Review of Erosion and Sedimentation Program Delegation to the North Carolina Department of Transportation, Division of Highways

November 30, 2010

North Carolina Department of Environment and Natural Resources Division of Land Resources Land Quality Section The Land Quality Section reviewed the program delegation to the Department of Transportation, Division of Highways (DOT) on September 13 and 14, 2010. The projects selected for review were a mix of contract construction, design-build and maintenance. The review and the results reported here are in accordance with requirements of the Sedimentation Control Commission (SCC) delegation to the DOT.

NC 225, Henderson County, poor preparation

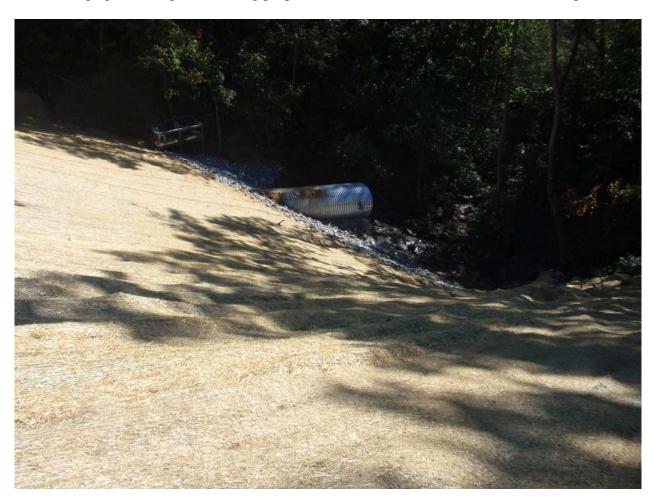
Slope preparation

Graded slopes and fills need adequate seedbed preparation.
